**TO:** Distribution **DATE:** April 10, 1995  
**FROM:** Phil Nixon **DOC #:** SP307:041195:01  
**PROJECT:** Solar Evaporation Ponds, OU4 IM/IRA  
**SUBJECT:** 60% Design Review Meeting

**SUBJECT:** Comments on 60% Design Package

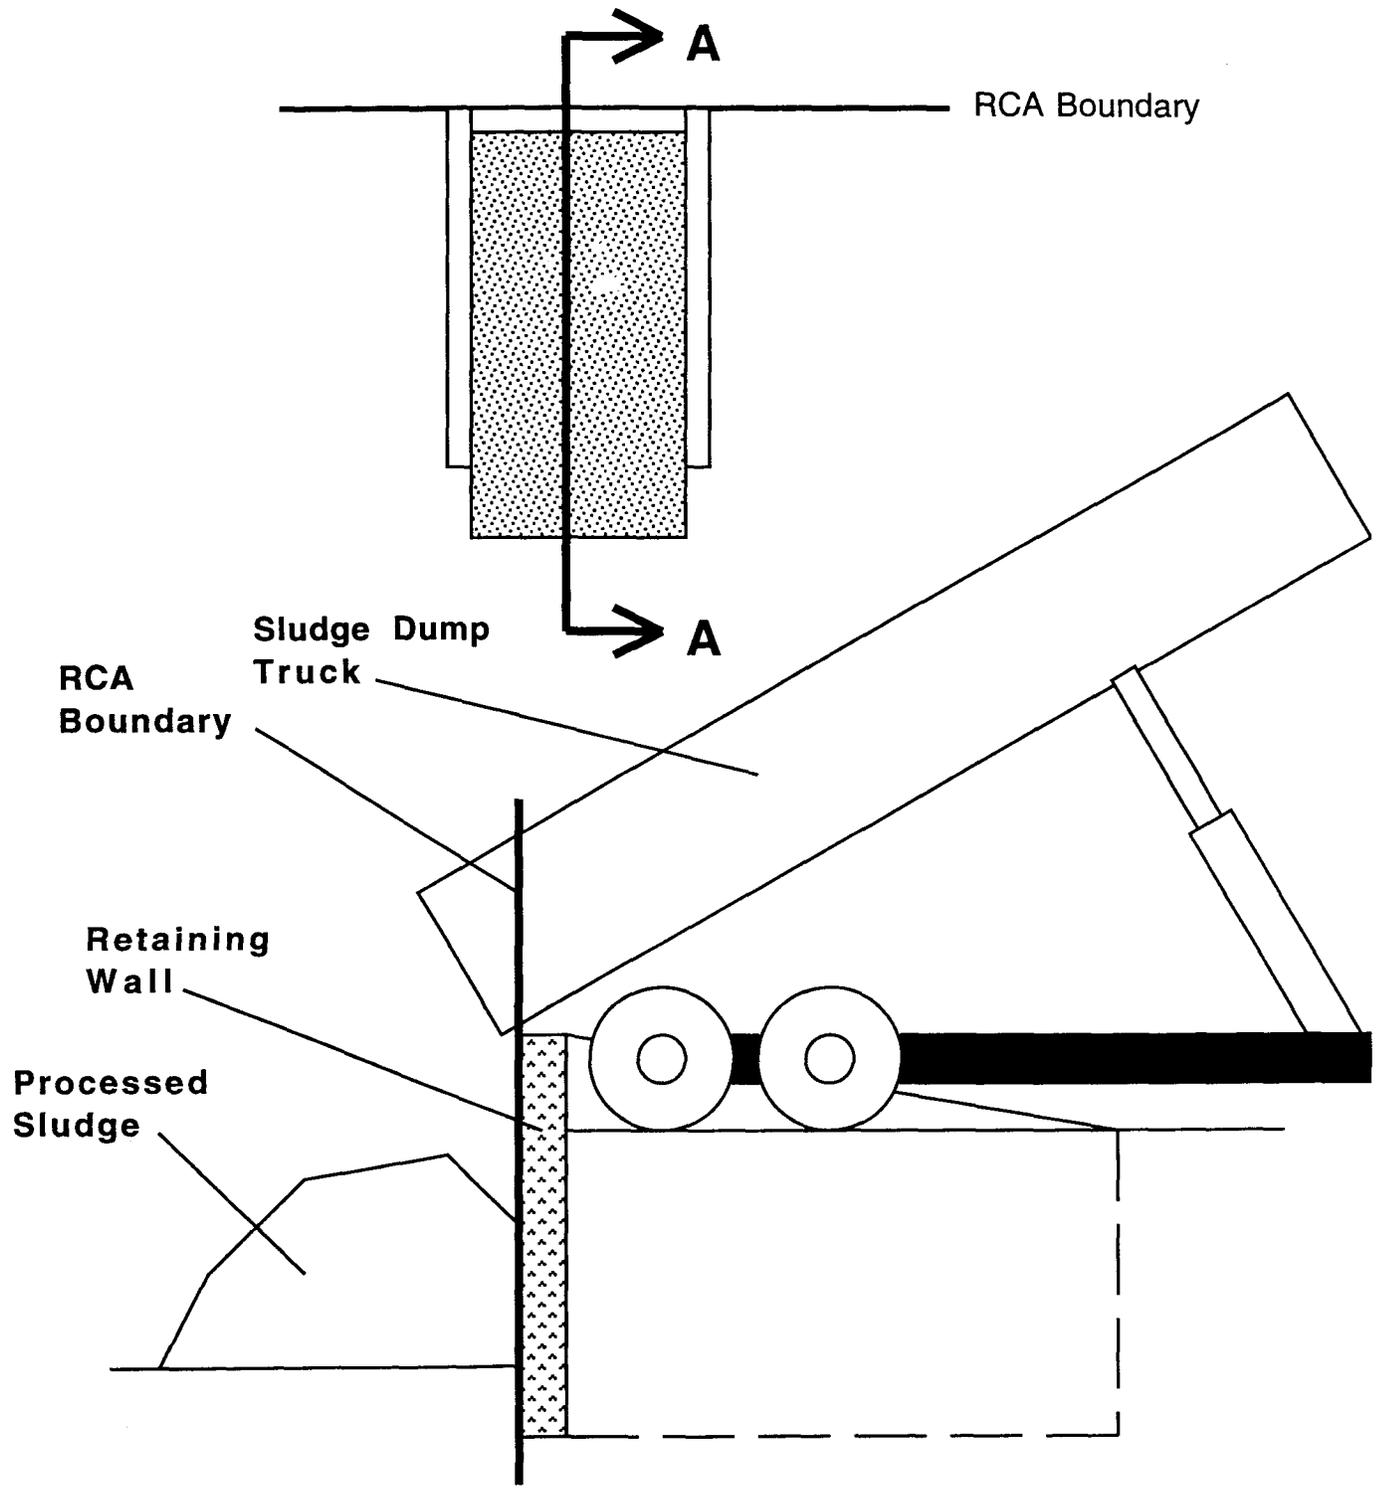
5.1	R	General	ES needs to design a location and provisions to allow the processed pondcrete materials to be dumped into the RCA boundary without having the trucks enter the RCA. I envisioned somethin like the sketch below:
